Metro Inner Development Assessment Panel Agenda

1. Declarations of Due Consideration
2. Disclosure of Interests
3. Form 1 DAP Applications
 - 3.1 117-119 (Lots 207 & 206) Lockhart Street, Como - 14 Grouped Dwellings – DAP/24/02645
4. Form 2 DAP Applications
5. Section 31 SAT Reconsiderations

DAP Name:	Metro Inner Development Assessment Panel
Local Government Area:	City of South Perth
Applicant:	Urbanista Town Planning
Owner:	Olivii Pty Ltd
Value of Development:	\$7.7 million
Responsible Authority:	City of South Perth
Authorising Officer:	Fiona Mullen, Manager Development Services Scott van Ierland, Senior Urban Planner
LG Reference:	PDDA-2023/2055
DAP File No:	DAP/2024/02645
Application Received Date:	31 January 2024
Report Due Date:	9 August 2024
Application Statutory Process Timeframe:	90 Days
Attachment(s):	1. Aerial Image and Zoning Map 2. Schedule of Submissions 3. Design Review Panel Minutes 4. Solar Access Diagrams 5. Development Plans 6. Environmentally Sustainable Design Report 7. Waste Management Plan 8. Traffic Impact Statement 9. Acoustic Report 10. Section Drawings

SWEPT PATHS

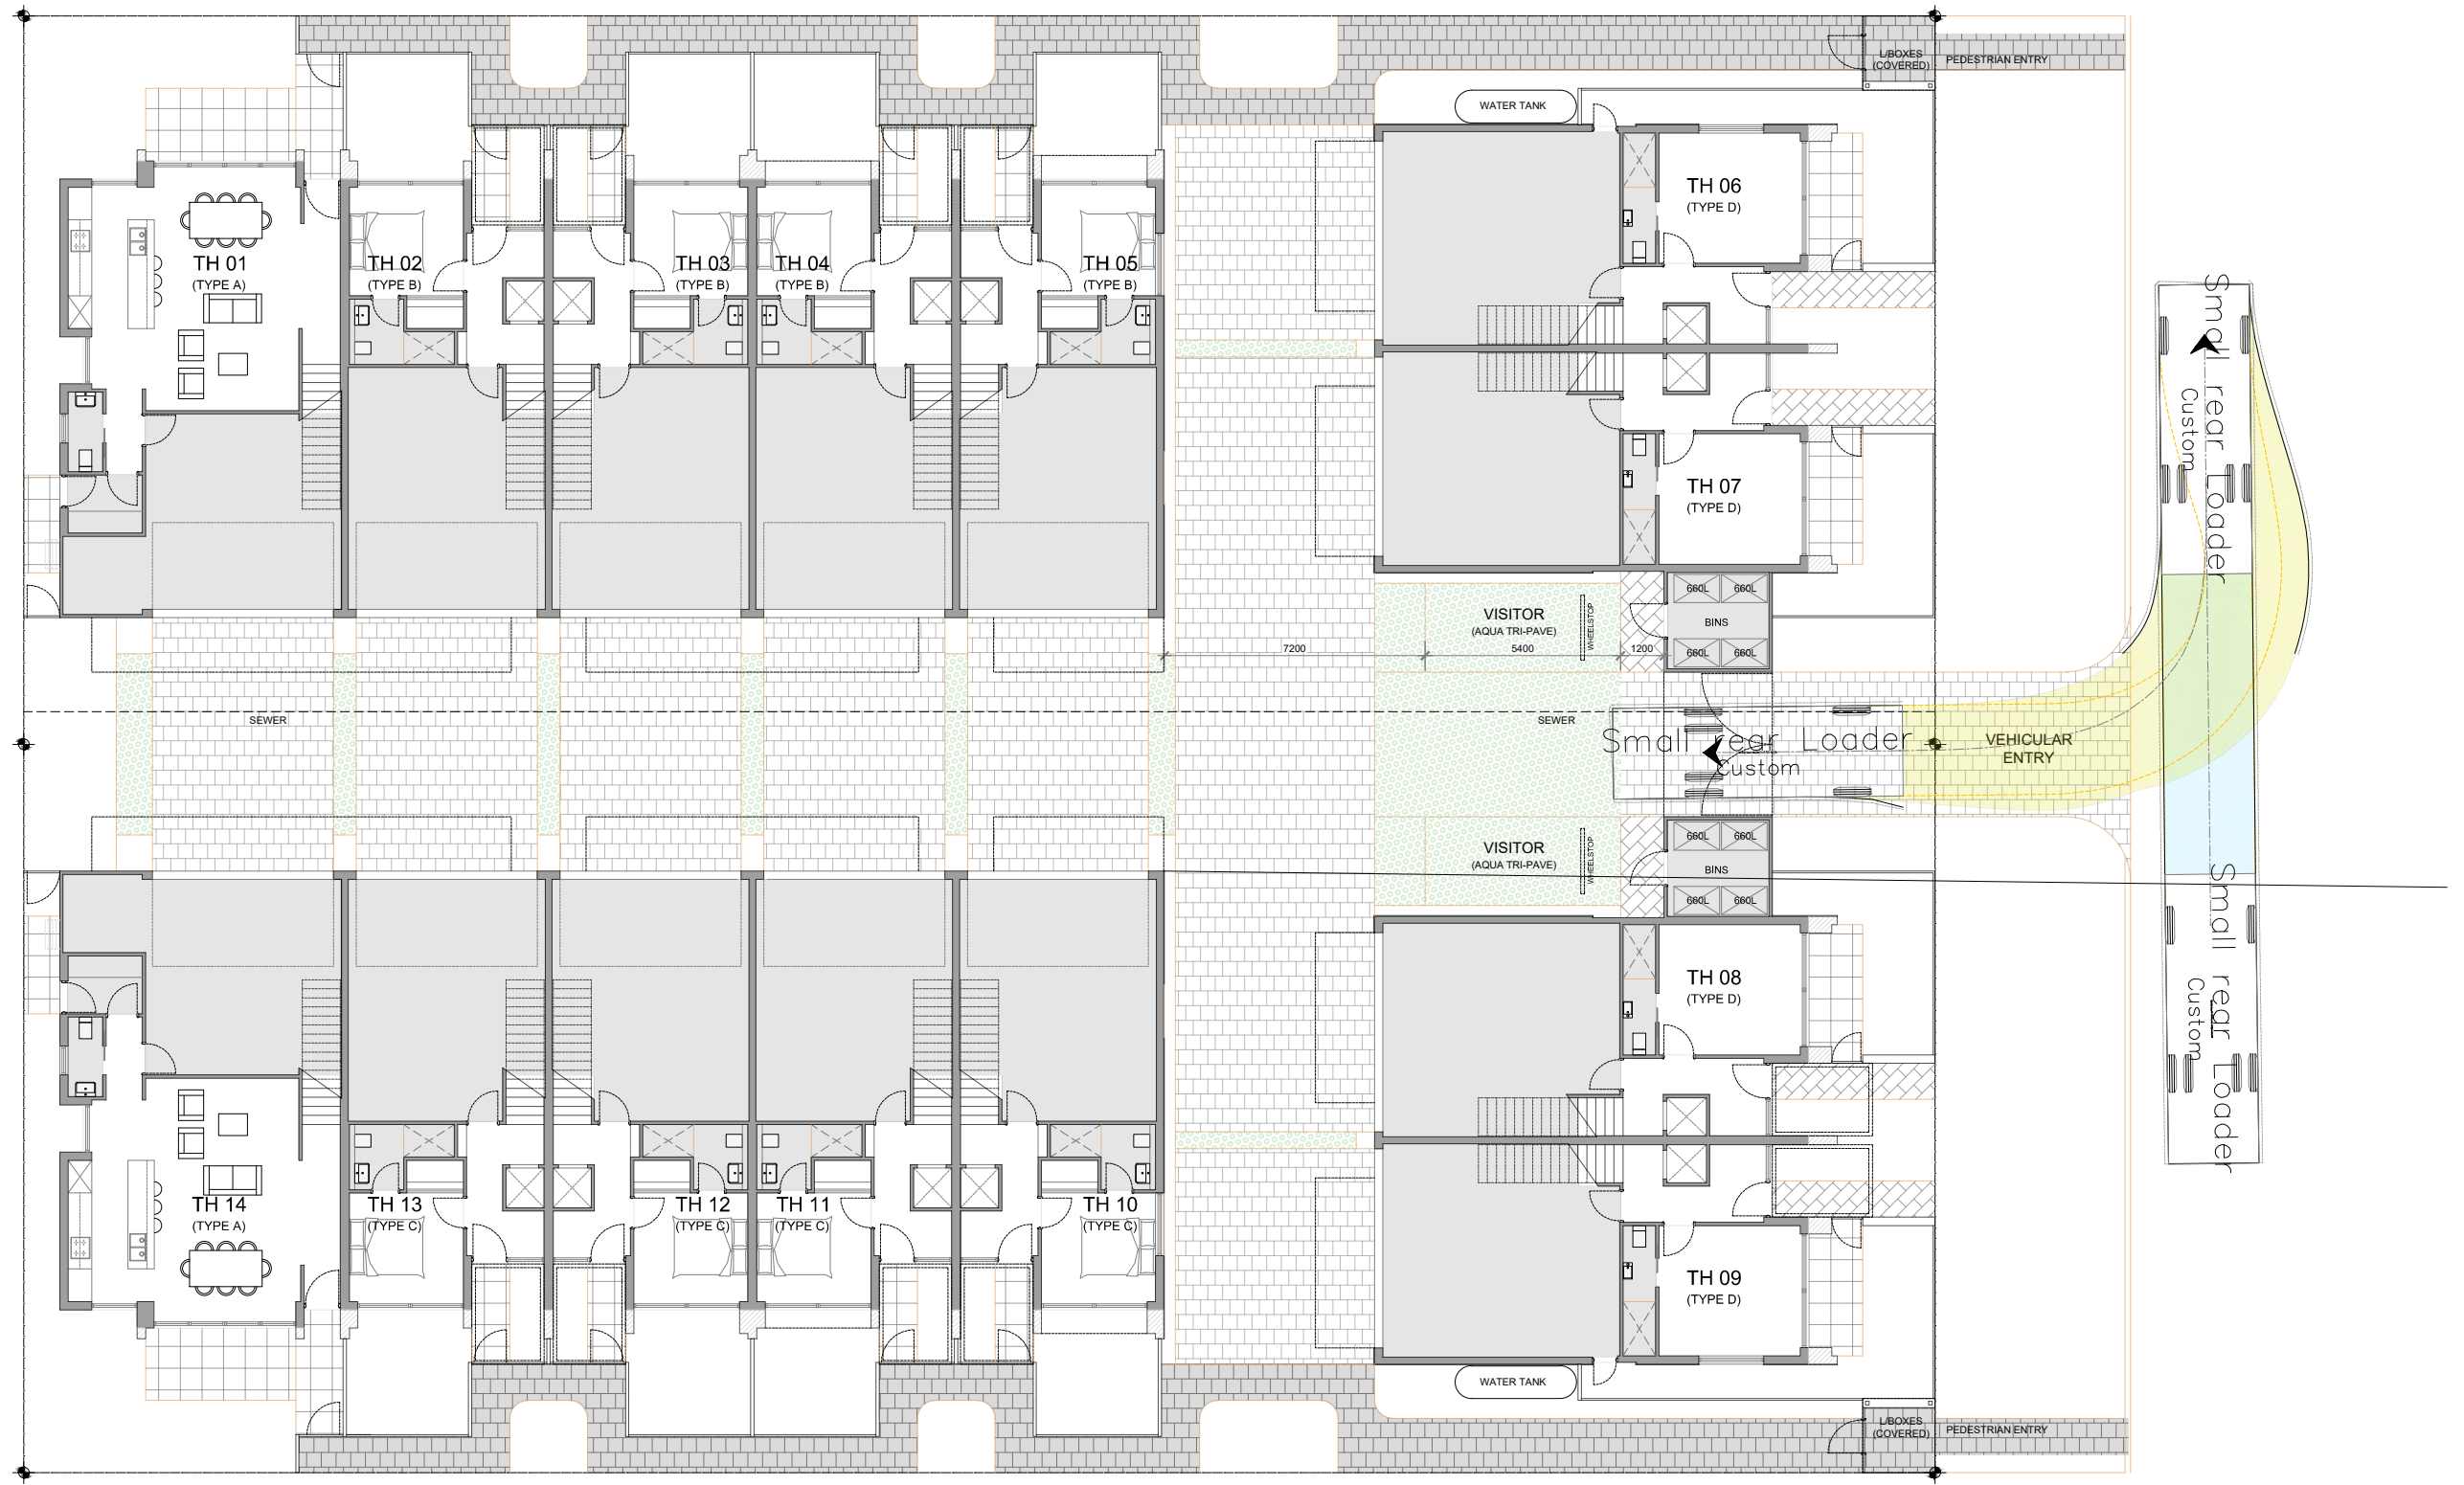
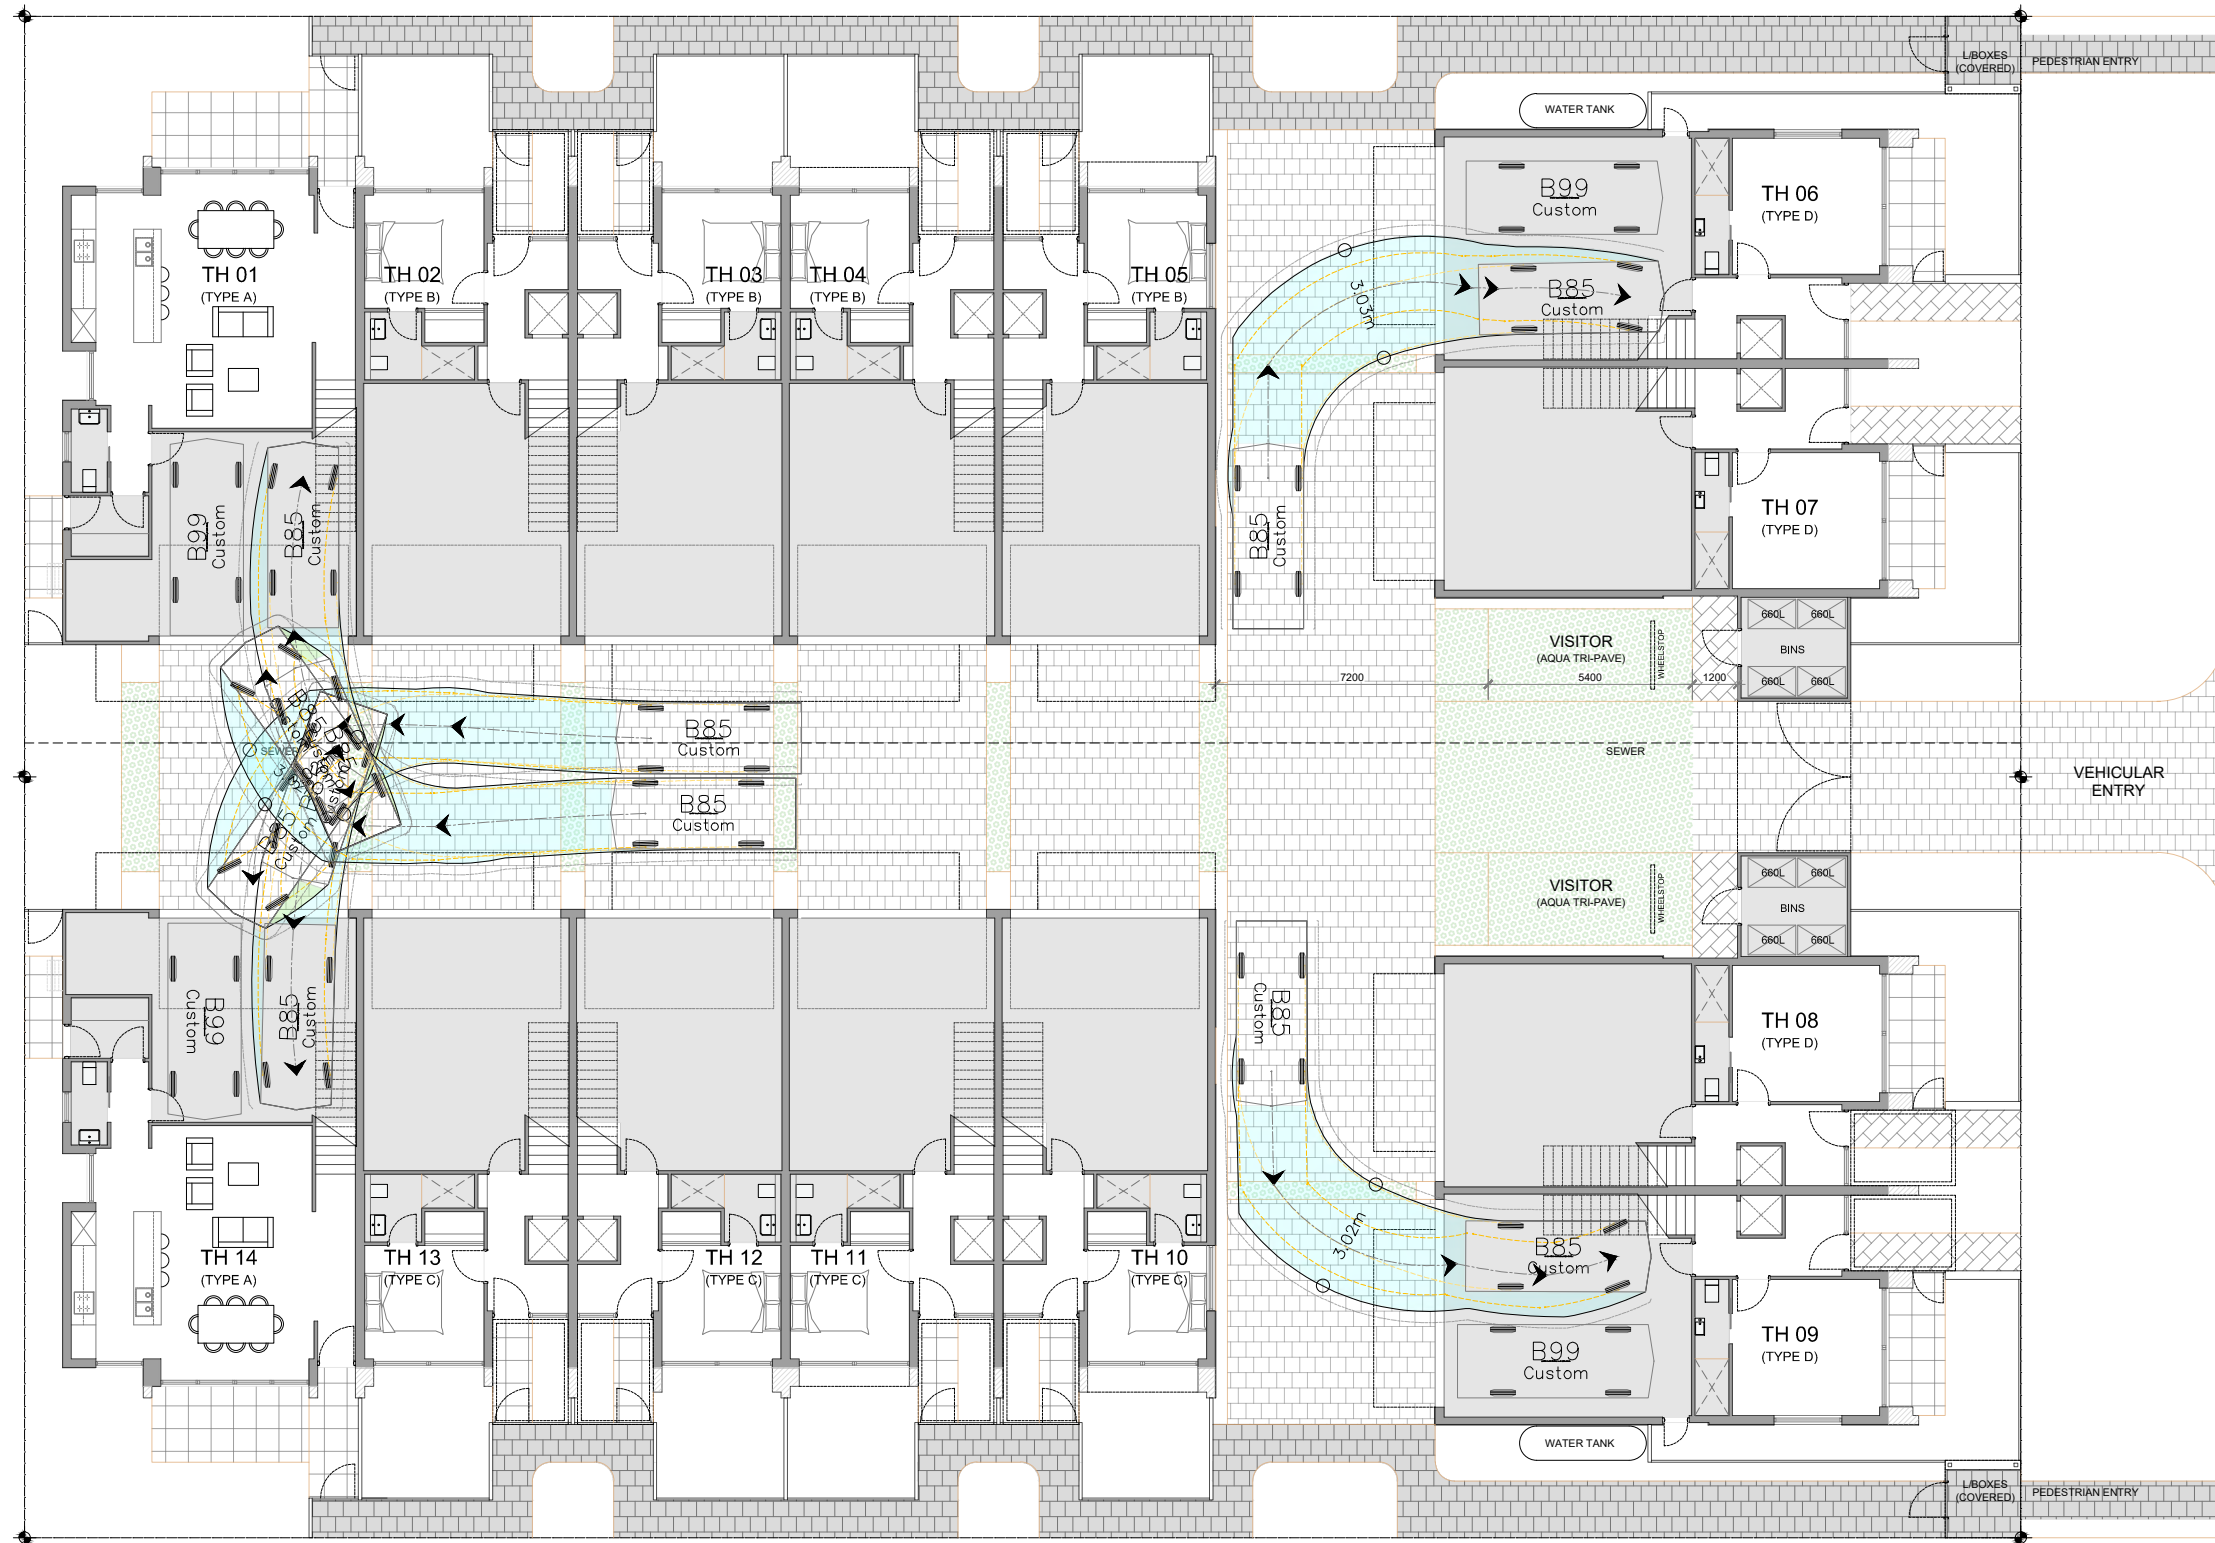
The development proposes on site waste servicing by a private contractor. The Waste Management Plan (WMP) is contained as **Attachment 7**. The proposed WMP requires the waste vehicle to reverse into the subject site to facilitate waste collection, with vehicle manoeuvring occurring within the adjoining public street and verge abutting the site.

The City has reviewed the submitted WMP at **Attachment 7**. The WMP proposes the use of a private contractor to provide a small rear loading waste vehicle to service the site bi-weekly (both general waste and recycling). The waste vehicle is proposed to reverse into the site with manoeuvring occurring within the road and adjoining verge, crossing the centreline of the road before entering the development.

Figure 1: Aerial view of development site and surrounding area.

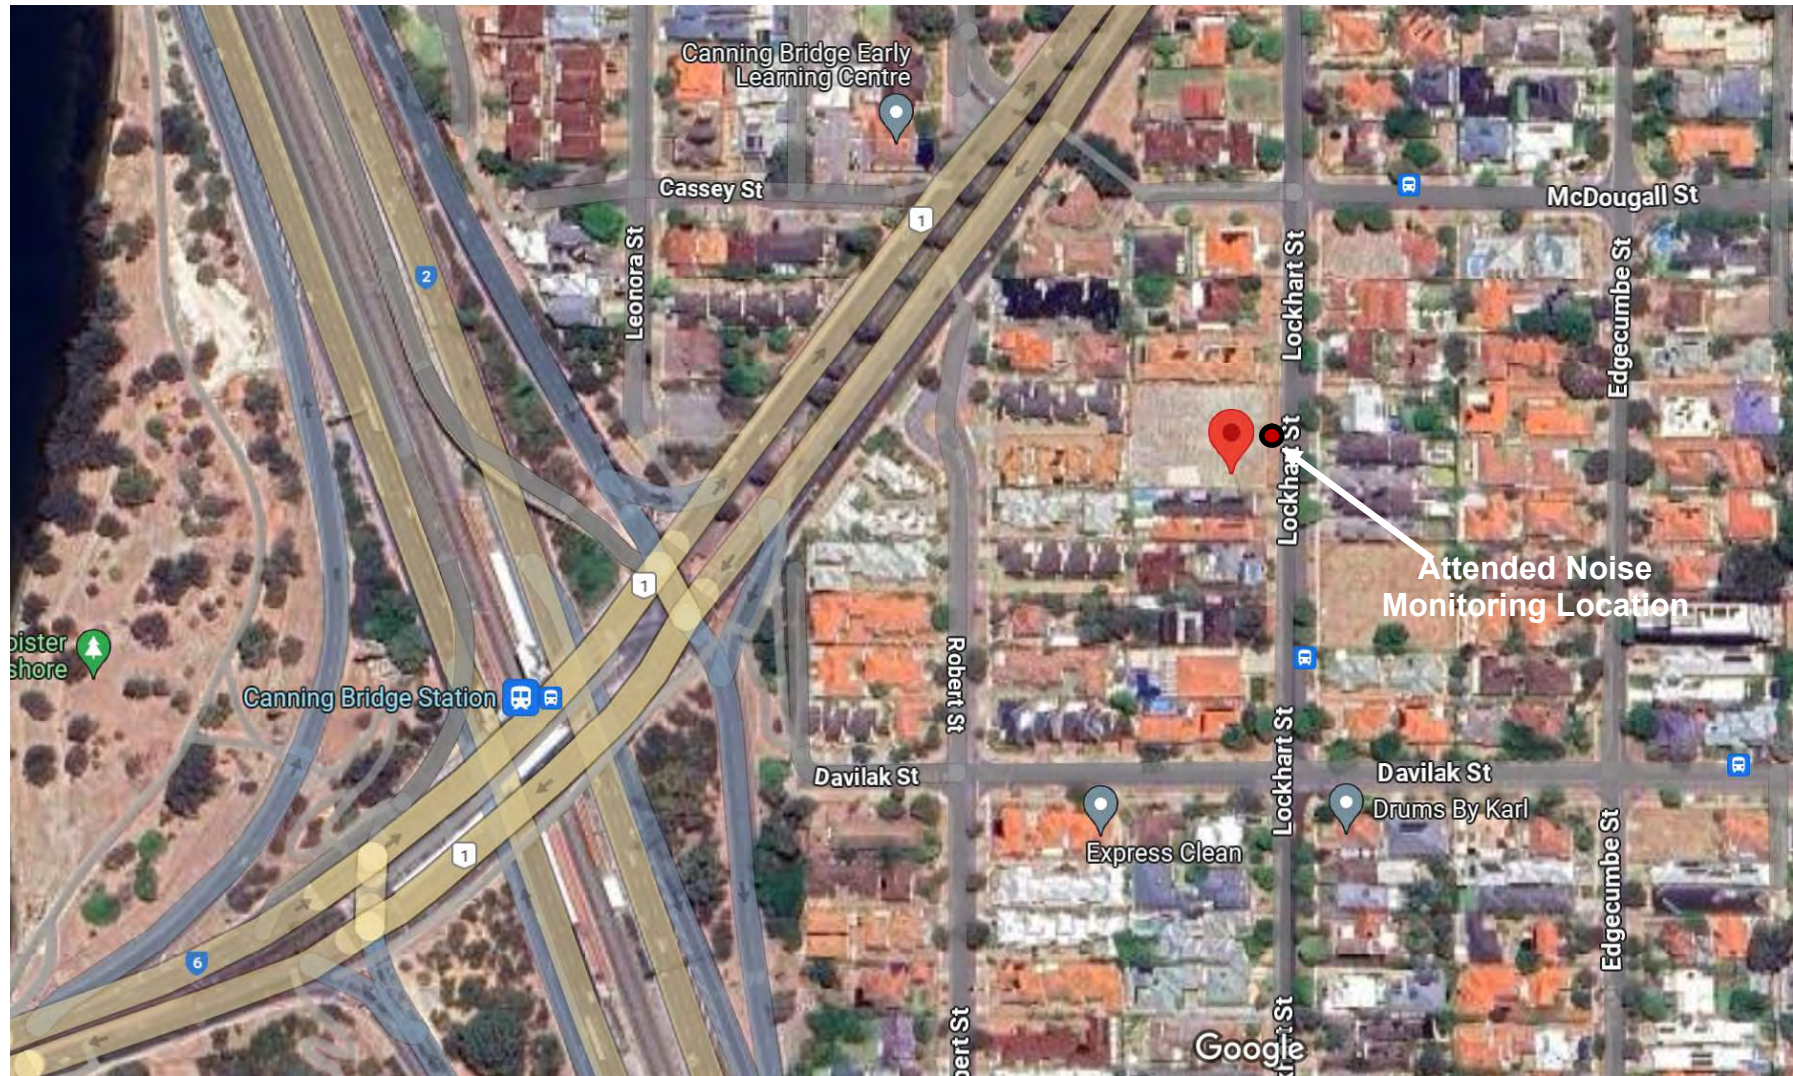
Appendix A, Figure 1, shows an aerial, however the carriageway information used and distance to determine exposure forecast has not been stated. The report only makes mention of which floor floor/dwelling falls into what exposure category and then specifies the applicable quiet house package, with Appendix C showing façade orientation.

Should the application be approved, a condition requiring an updated Acoustic Report addressing the requirements of State Planning Policy 5.4 - Road and Rail Noise, as well as onsite noise sources such as air conditioning units and waste vehicles is recommended. Further, a noise management plan prepared by a suitably qualified person is also recommended to confirm the measures contained in the Acoustic Report have been satisfactorily implemented.
